**An assessment of facilities at the North West
Transport Hub**

(April 2020)

About this report

(The image on the left is the interior of the male toilets. The image on the right is the interior of the Changing Places facility.)

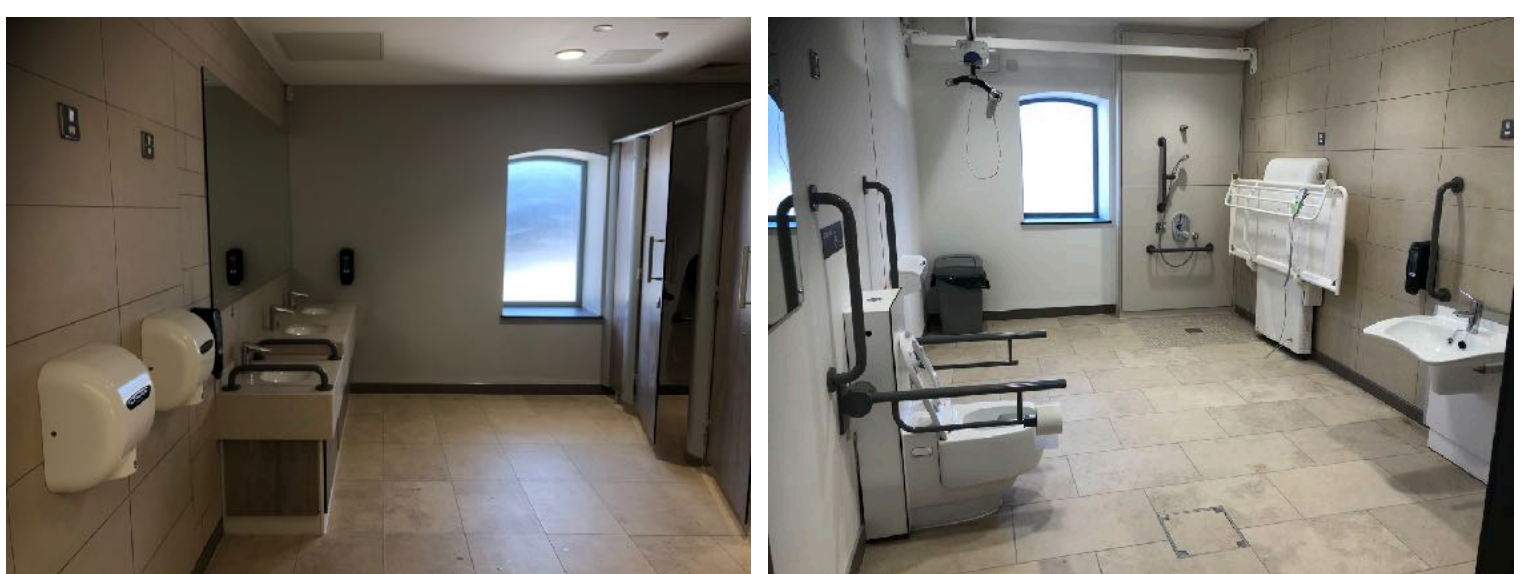
The North West Transport Hub provides the full range of toilet facilities including a Changing Places facility meeting design standards, a generous, separate accessible toilet, a generously proportioned parent / baby changing room and standard male and female facilities meeting inclusive design standards. The Committee believes the toilet provision at the station provides an exemplar and should be used as the benchmark for future new and refurbished Translink stations.
